SUNDRY NOTICES AND REPORTS ON WELLS

8. Well Name and No.
POLO AOP FEDERAL 1

9. API Well No.
30-015-28170

Polo AOP Federal 1
30-015-28170
Yates Petroleum Corporation
Conditions of Approval

AFTER

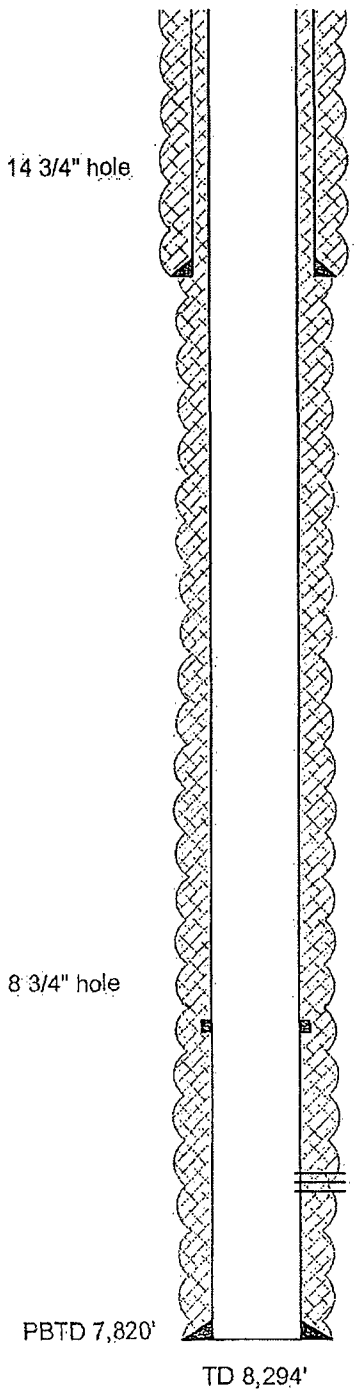
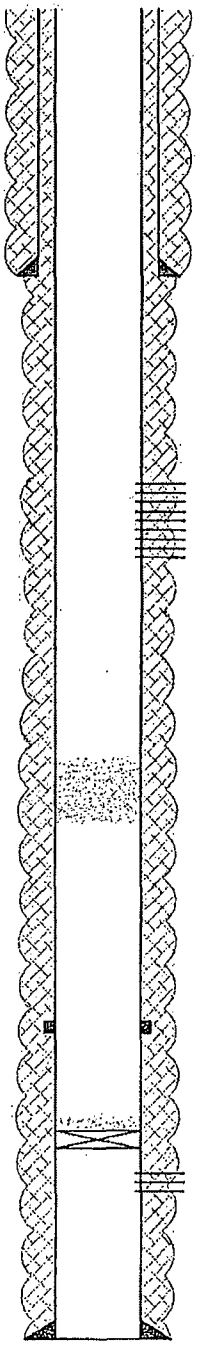
1. **Operator shall set a CIBP at 7,690' and place 25 sacks Class H cement. WOC and tag.**

2. **Operator shall spot a class C cement plug from 6081'-5763'. WOC and tag. (DV tool at 6031' and Wolfcamp at 5813')**

3. **Plug set at 4750' must be a minimum of 25 sacks and 150' in length**

4. **Must conduct a casing integrity test before perforating and fracturing. Submit results to BLM. The CIT is to be performed on the production casing to max treating pressure. Notify BLM if test fails.**
